ADDENDUM NUMBER ONE

**RMS & FRMS GYMS, WHHS BLDG Y & HCPS C.O. ROOF REPLACEMENTS
HENDERSON COUNTY PUBLIC SCHOOLS**

MLA PROJECT NUMBER: 20004

DATE OF ISSUE: June 29, 2020

**RUGBY MIDDLE
SCHOOL GYM
ROOF PLAN**

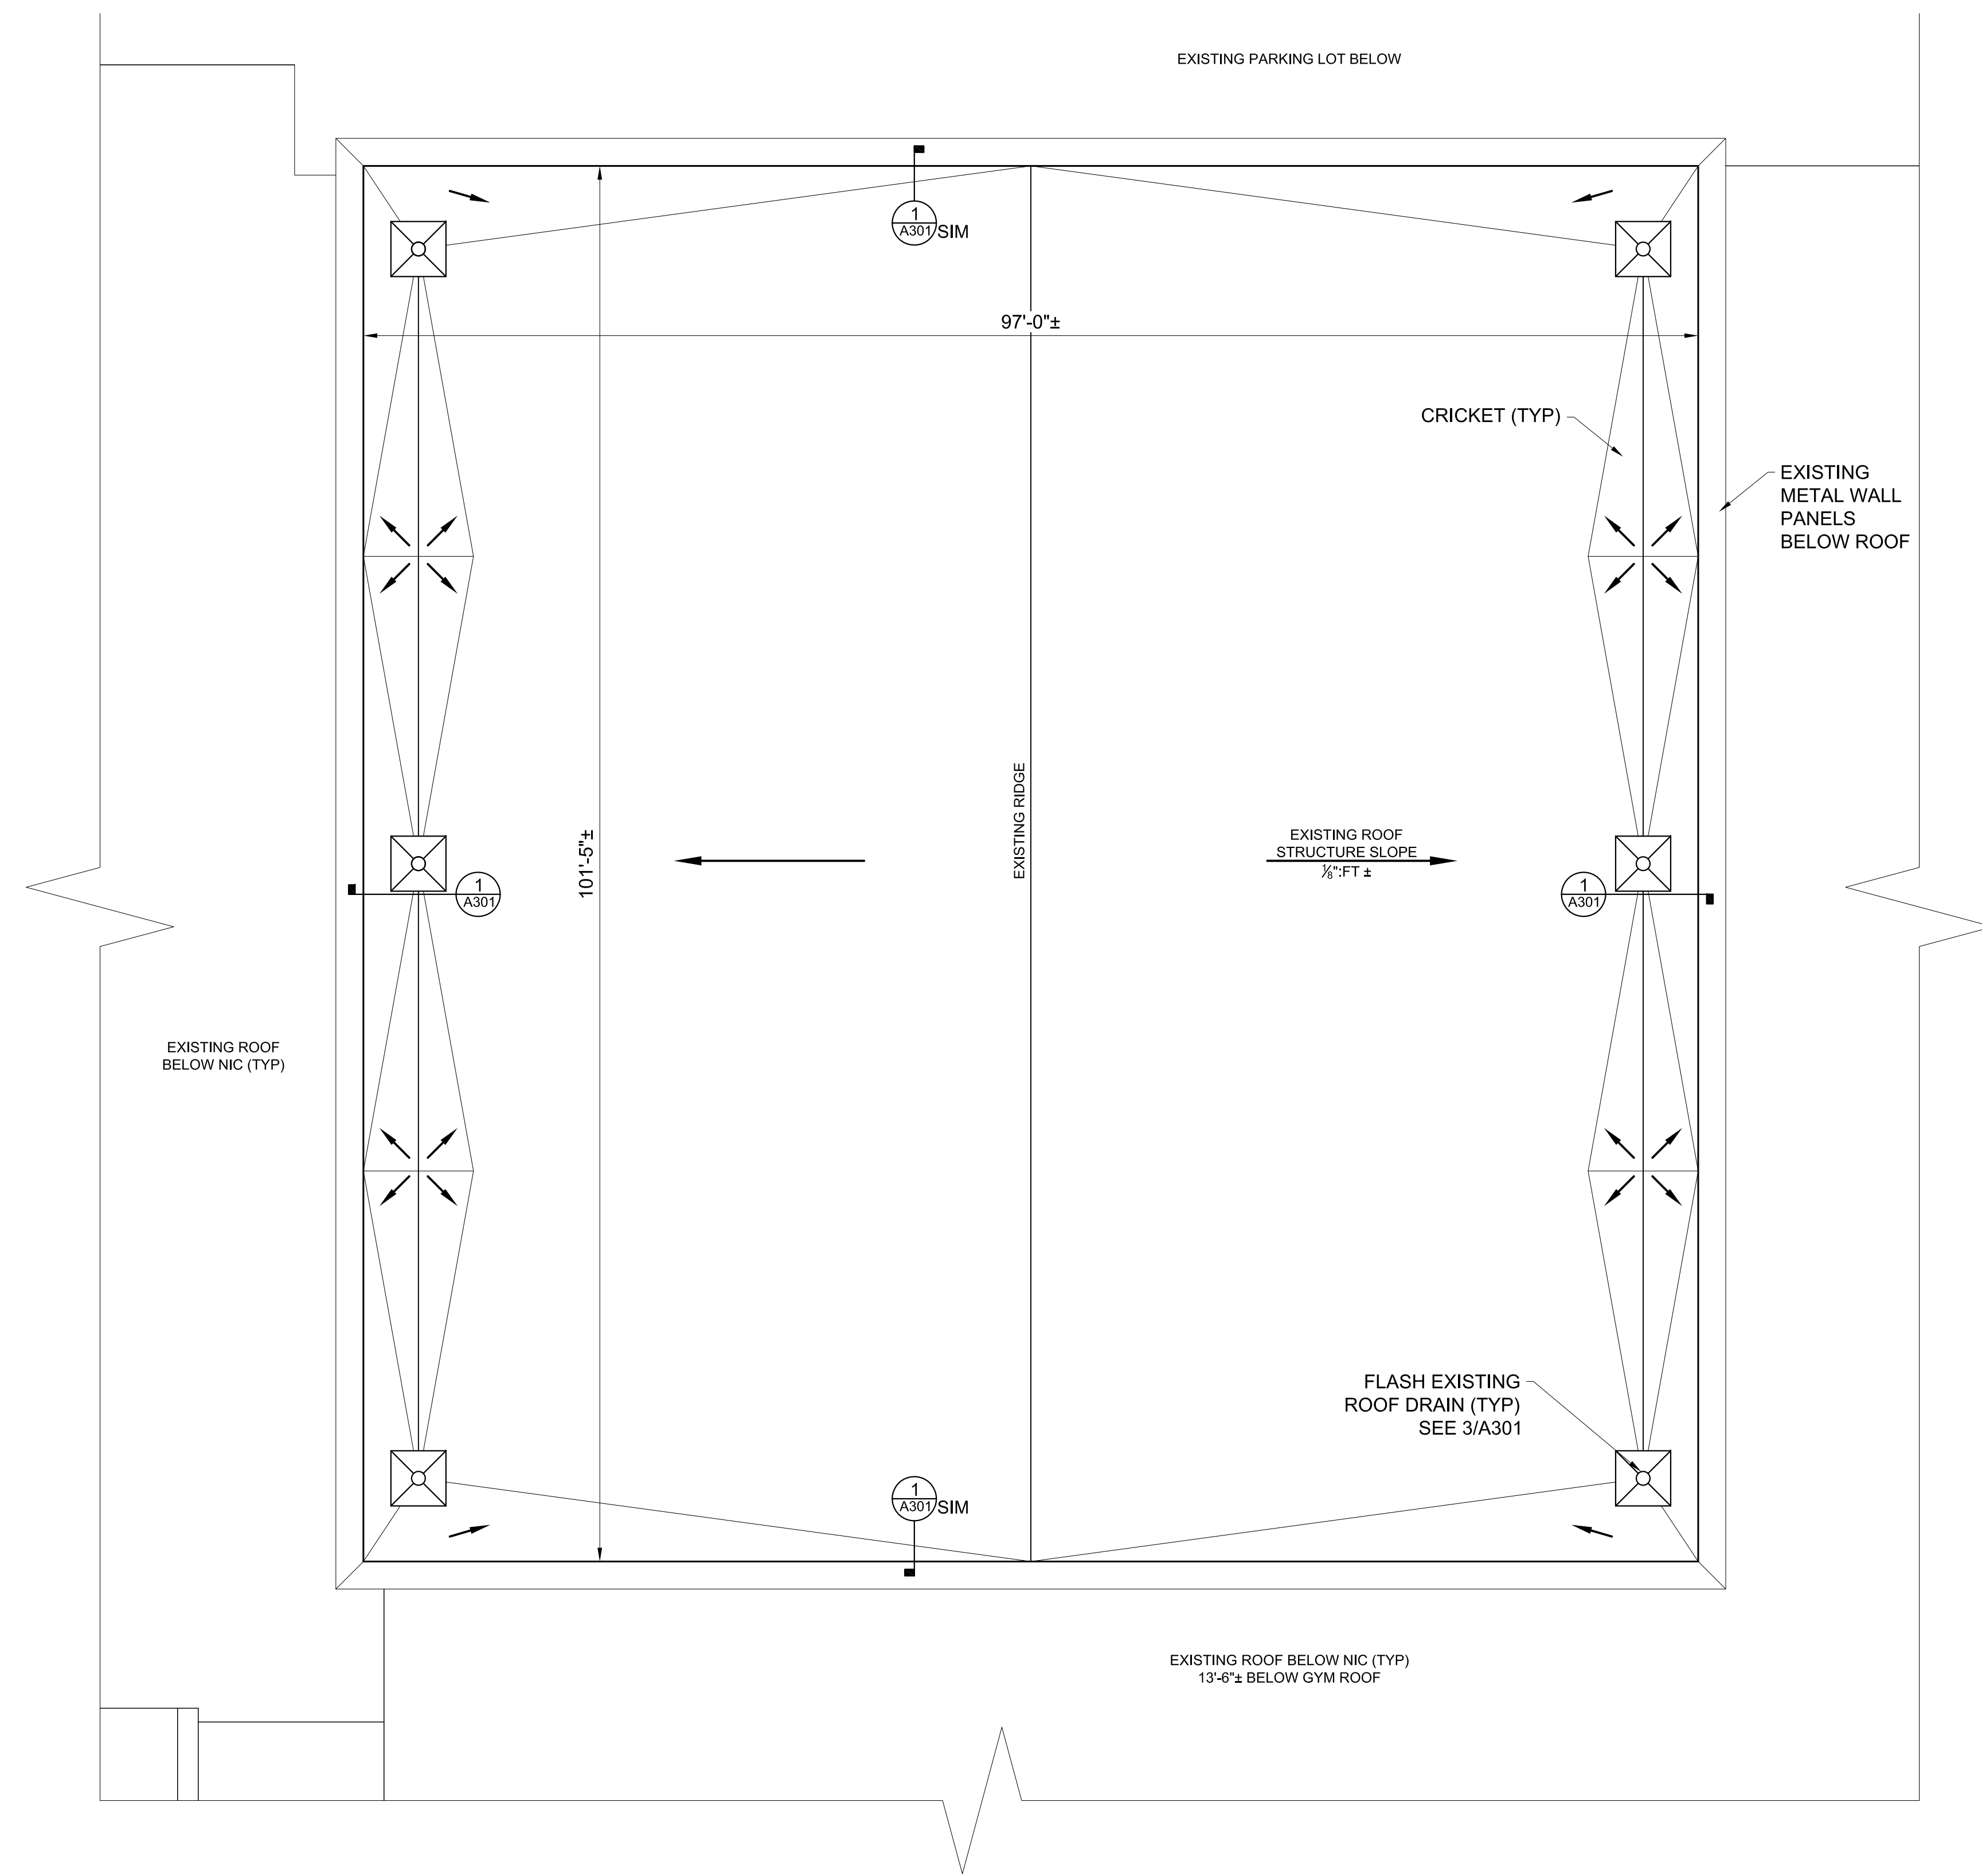
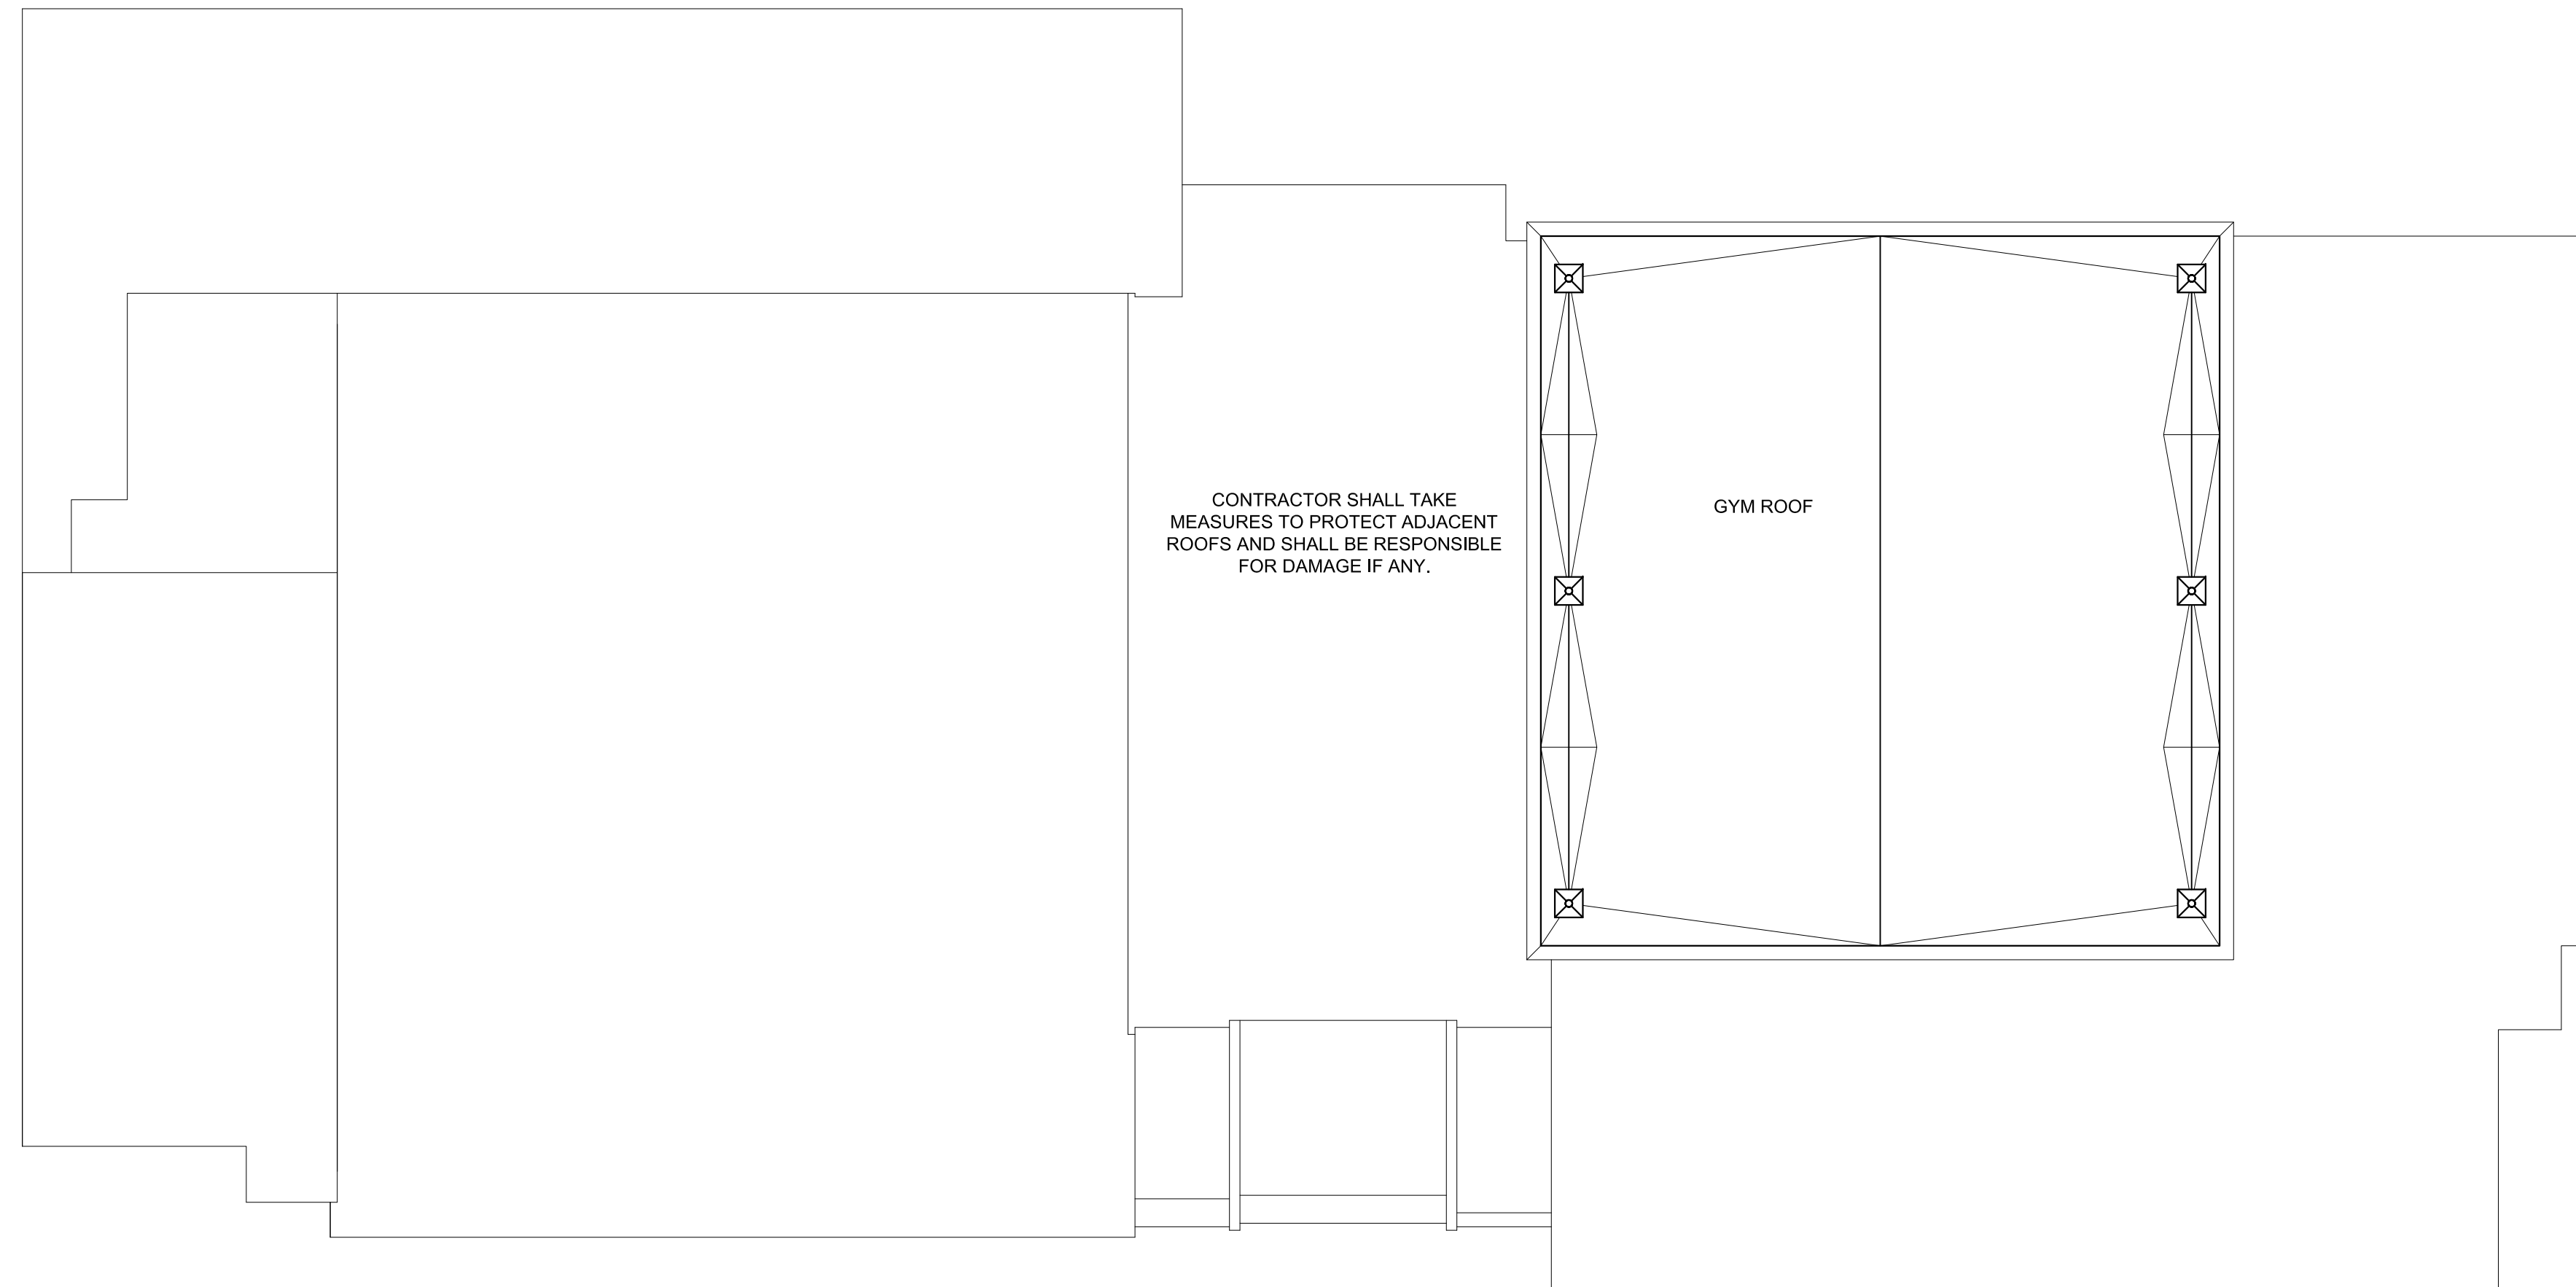
1. A201: See attached for revisions
2. A203: See attached for revisions
3. A204: See attached for revisions
4. A205: See attached for revisions
5. A301: See attached for revisions

Addendum 1: 6/29/20

BASE BID

2. DEMOLITION: REMOVE EXISTING MODIFIED BITUMEN & POLYISO INSULATION. REMOVE EXISTING ROOFING SYSTEM COMPONENTS INCLUDING FLASHING. EXISTING B.U. ROOFING SHALL REMAIN.

3. PROVIDE FULLY ADHERED 60 MIL TPO MEMBRANE ROOFING SYSTEM, AND 2.6" POLYISO INSULATION OVER EXISTING BUILT-UP ROOFING. ATTACH INSULATION THROUGH INTO EXISTING CWFD.

ALTERNATE NO.1

2. DEMOLITION: REMOVE EXISTING MODIFIED BITUMEN. REMOVE EXISTING ROOFING SYSTEM COMPONENTS INCLUDING FLASHING. EXISTING B.U. ROOFING & POLYISO INSULATION SHALL REMAIN.

3. PROVIDE FULLY ADHERED 60 MIL TPO MEMBRANE ROOFING SYSTEM, AND ½" HD BOARD OVER EXISTING POLYISO INSULATION. ATTACH INSULATION THROUGH INTO EXISTING CWFD.

**FLAT ROCK
 MIDDLE
 SCHOOL GYM
 ROOF PLAN**

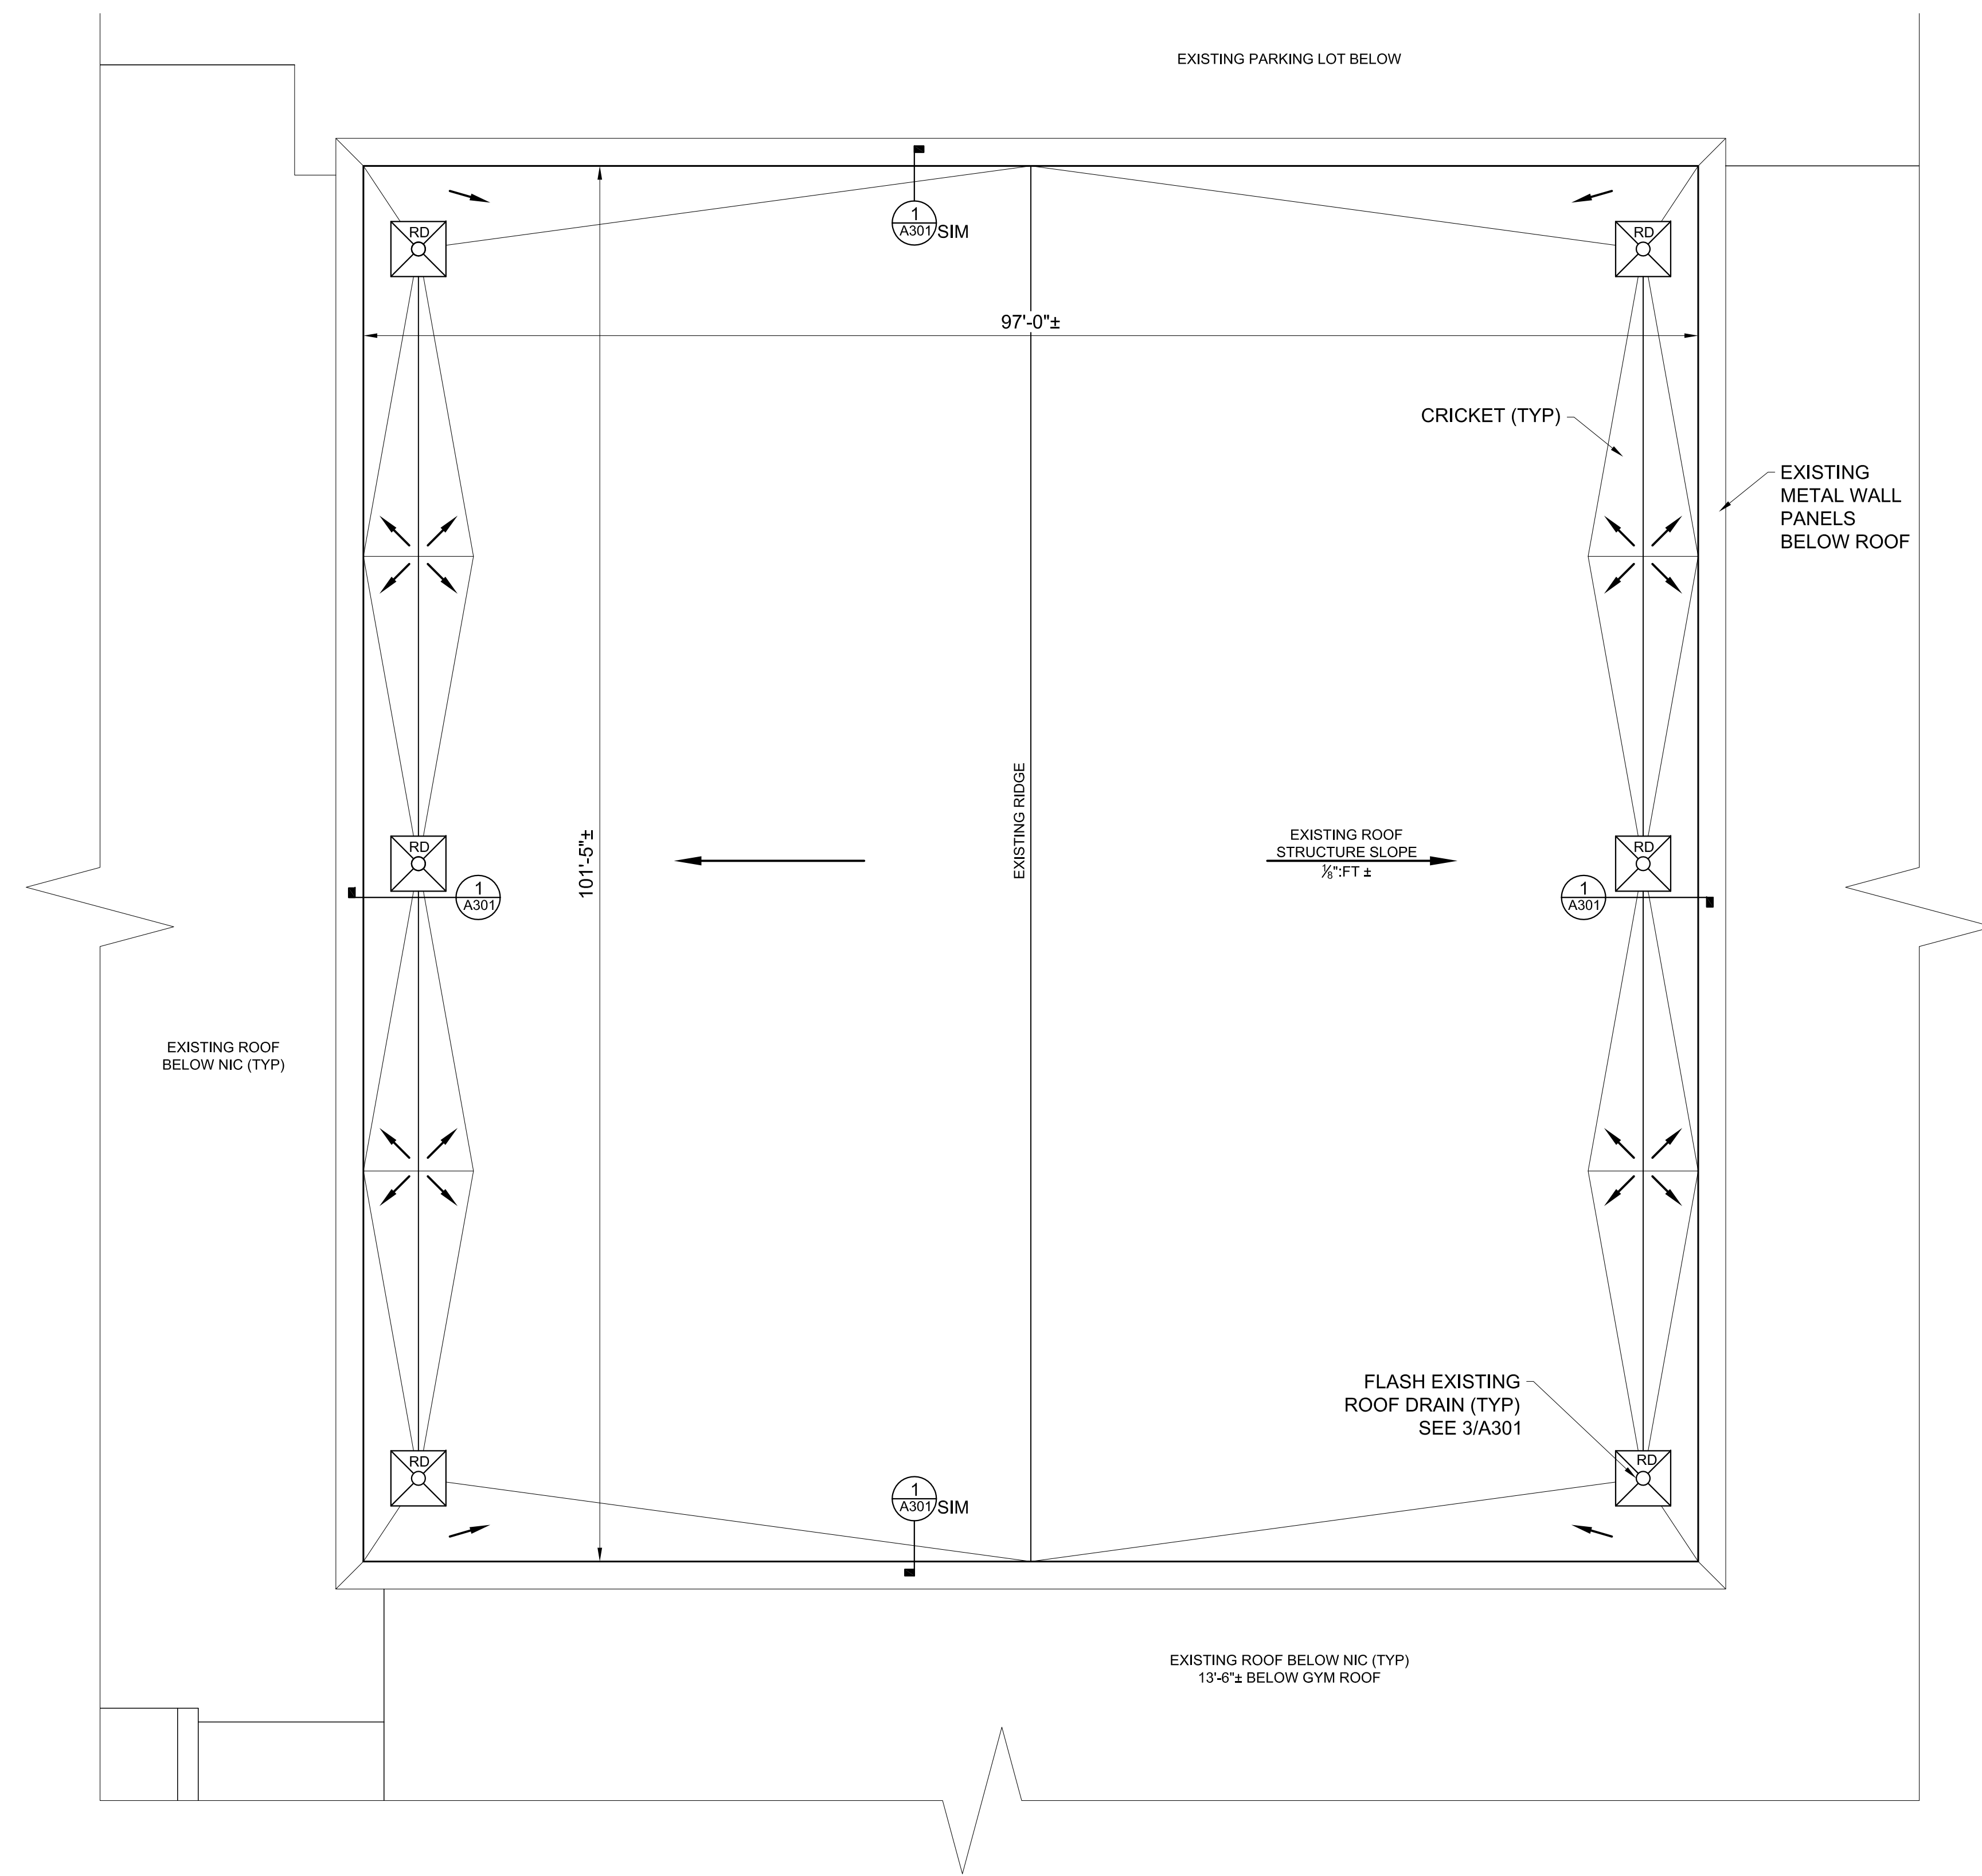
Project Number: 20004
 Checked: _____
 Drawn: A. Rognas
 Date: 6/22/20
 Revisions: _____
 Addendum 1: 6/29/20

- MECHANICALLY ATTACHED SPM SYSTEM
- MECHANICALLY ATTACHED 1/2" UNDERLAYMENT **FIBERBOARD**
- 1 1/2" POLYISO INSULATION
- BUILT-UP ROOFING
- CWFD- 3" THICK

2. DEMOLITION: REMOVE EXISTING SPM & UNDERLAYMENT BOARD. REMOVE EXISTING ROOFING SYSTEM COMPONENTS INCLUDING FLASHING. EXISTING B.U. ROOFING & POLYISO INSULATION SHALL REMAIN.

3. PROVIDE FULLY ADHERED 60 MIL TPO MEMBRANE ROOFING SYSTEM, AND 1/2" UNDERLAYMENT BOARD OVER EXISTING POLYISO INSULATION. ATTACH INSULATION THROUGH INTO EXISTING CWFD.
